1. New Primary School in Edmondson Park – Request for further Information

ptc. has been engaged by Richard Crookes Constructions on behalf of School Infrastructure NSW (SINSW) to address comments received following the submission of the State Significant Development Application (SSDA) for the proposed development of a new primary school at Buchan Avenue in Edmondson Park.

Figure 1 - Edmondson Park South Masterplan by Landcom

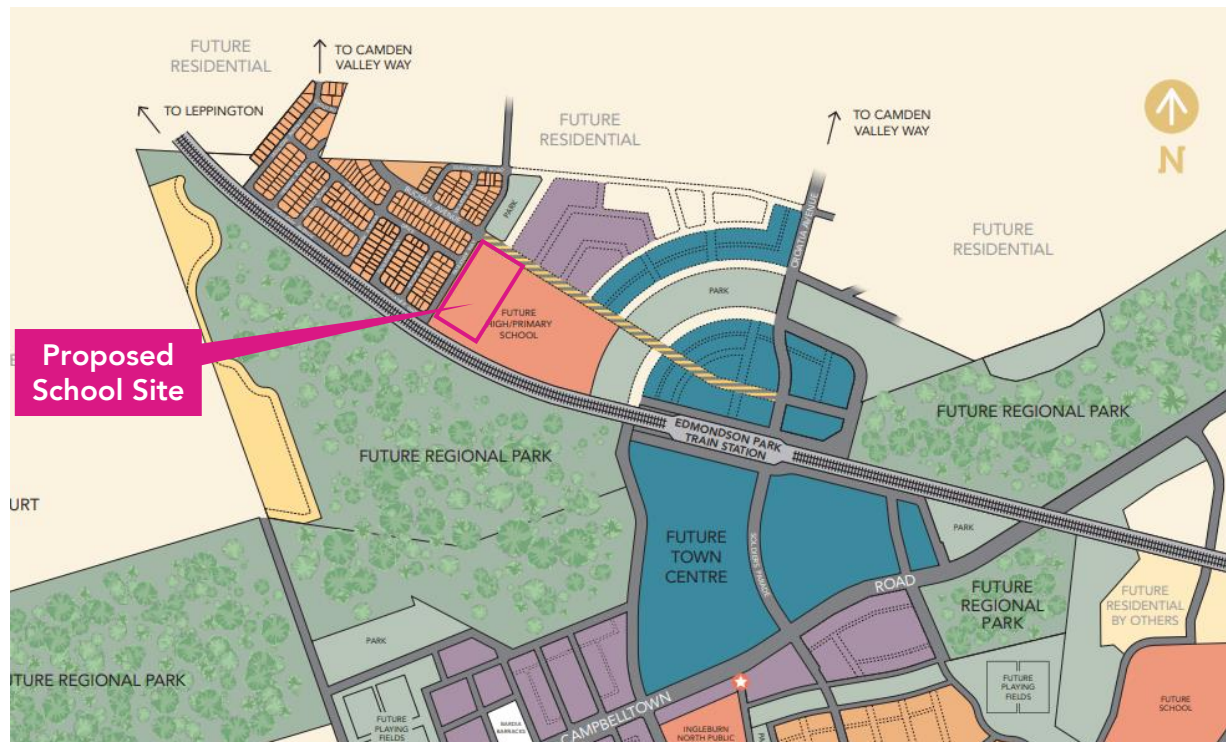
It should be noted that the VISSIM model of the area prepared by AECOM as part of the Transport Management and Accessibility Plan for Edmondson Park South – Concept Plan (MOD 5) has not been endorsed by Council. The proponent needs to confirm whether the proposed access to the school off Faulkner Way was previously modelled in the AECOM traffic models.

To our knowledge, the access to the school off Faulkner Way was not previously modelled by AECOM. However, please see the below, which provides an overview of assumptions made about the school site since the original masterplan.

The screenshot below shows the masterplan for the Edmondson Park South area prepared by Landcom in around 2010. The area originally allocated to the school was larger than the current development is seeking approval for.

Figure 7 - Drop-off / Pick-up Vehicles exiting southbound

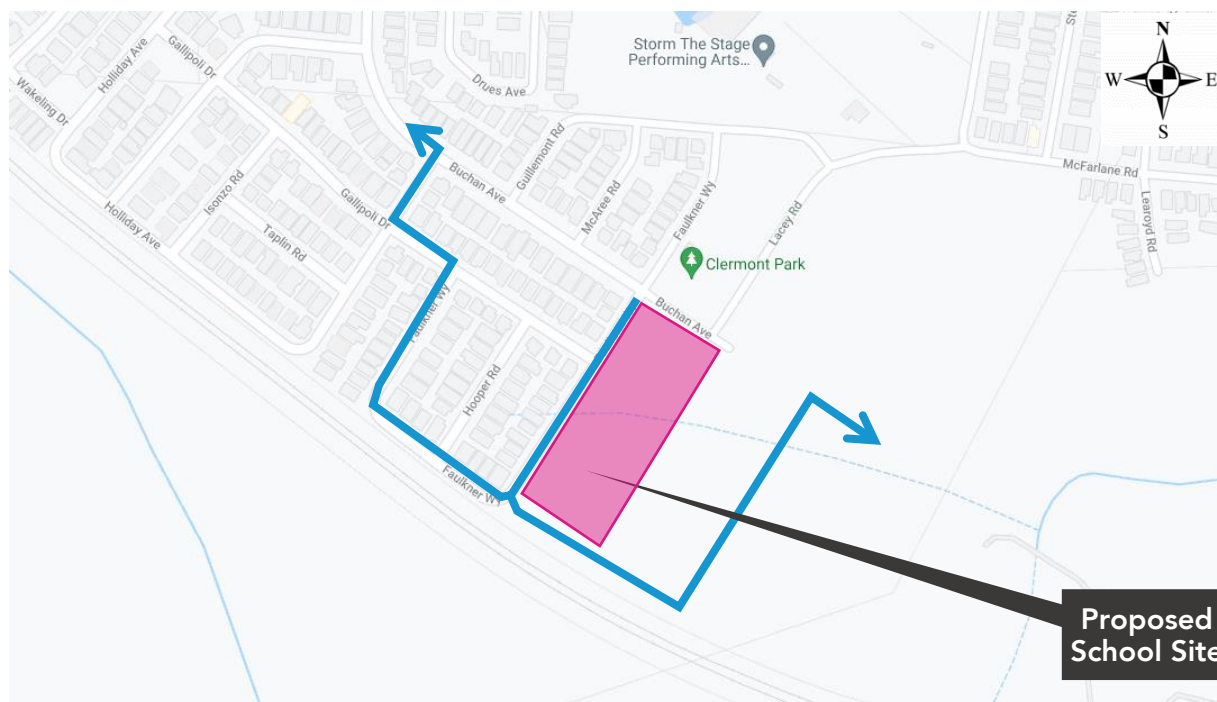
The SIDRA results in Attachment 1 of the traffic advice prepared by PTC show errors on the forecast traffic flows along Faulkner Way with only 14 vehicles in AM peak hour and 3 vehicles in PM peak hour. The vehicular trips in and out of the schools normally occur within the same hour during AM and PM peaks. Hence, it is recommended that an interim roundabout is to be installed at the intersection of Buchan Avenue/Faulkner Way when the student number reaches the required threshold. The threshold is to be identified and confirmed by Council. An interim roundabout is requested as a signalised intersection might be required as an ultimate treatment when the high school site is developed and operational

The previously submitted SIDRA model does not have any errors, but rather is based on the assumption that following the pick-up / drop-off along Faulkner Way, parents will continue on and turn left / right at the end of this road instead of undertaking U-turns. Undertaking U-turns would be less convenient and not advised. Upon the pick-up / drop-off, parents can drive southbound along Faulkner Way and either turn left into the future South Road to exit towards the east, or turn right and continue along Faulkner Way to exit further to the west. This is shown in Figure 7.

As the school is located at the southern end of the enrolment catchment, it is assumed that no students will arrive from the south.

Figure 12 - With Proposed Zebra Crossings

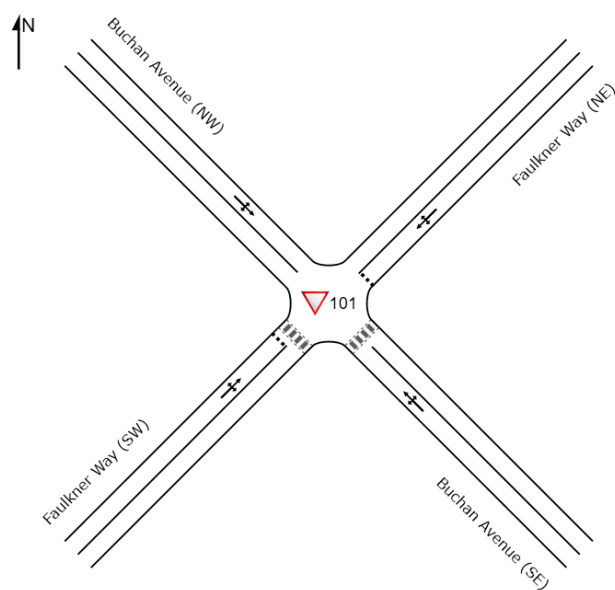
The proposed marked pedestrian crossings and their locations need to be referred to Council's Pedestrian, Active Transport and Traffic Committee for comment.

- Proposed scenario – with zebra crossings (refer to the below figure).

With the estimated number of pedestrians crossing the roads, all turn movements from the north-west approach of Buchan Avenue have a LoS D in the AM peak hour, the arm has a queue length of 350.1 meters and the DoS is above 100%, meaning that there is no spare capacity. Similarly, in the PM peak, the south-east approach of Buchan Avenue has a LoS C on all turn movements, a queue length of 168.3 meters and a 92% DoS. This result can be attributed to the high number of pedestrians using the Buchan Avenue crossing. In accordance with the modelling guidelines, a LoS C is “satisfactory” and D is “operating near capacity”, neither of which warrant an upgrade to the intersection. The LoS of the right turn movement from Faulkner Way southwest is D and C in the morning and afternoon peak hour respectively. This is due to the longer waiting time for vehicles exiting the minor road (Faulkner Way), which is not unusual for minor roads during peaks.

The intersection analysis shows that it is the pedestrian movements at the zebra crossings which is the major factor contributing towards the reduced performance of the intersection during the school peak hours, even with 20% of vehicles undertaking a U-turn and exiting via the Buchan Avenue / Faulkner Way intersection.

Vehicular traffic at a roundabout would be affected by pedestrians in the same way as traffic is affected at a priority-controlled intersection. Therefore, an upgrade of the Buchan Avenue / Faulkner Way intersection to a roundabout is not likely to improve the overall performance.

A way of improving the vehicular movements at this intersection would be to not install the proposed zebra crossings, which is not recommended for various reasons, the main ones being children's safety and encouragement of active transport.

Figure 13 – On-Street Parking Spaces on the vicinity of the Site

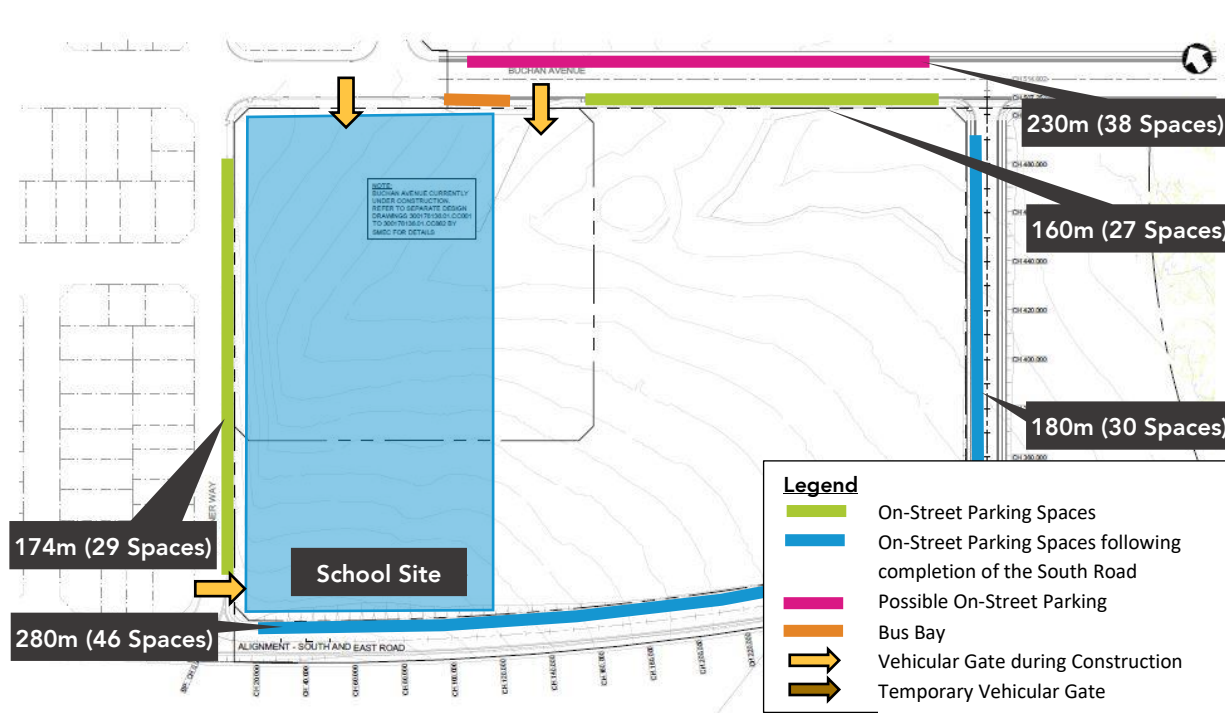
Submission of a Street Parking Demand Survey reviewing usage and availability of street parking in vicinity of the site, to support the proposed reduced on-site parking provision during operation and off-site parking proposed during construction.

The on-street parking spaces available in the vicinity of the site are shown in Figure 13. Approximately 56 spaces as marked by green lines would potentially be available for construction staff at all times during the construction period, as these are directly adjacent to the development site and there are no other attractors in the vicinity which generate a demand for parking.

Approximately 38 on-street parking spaces as marked by pink lines in Figure 13 may be available temporarily or periodically for the following reasons:
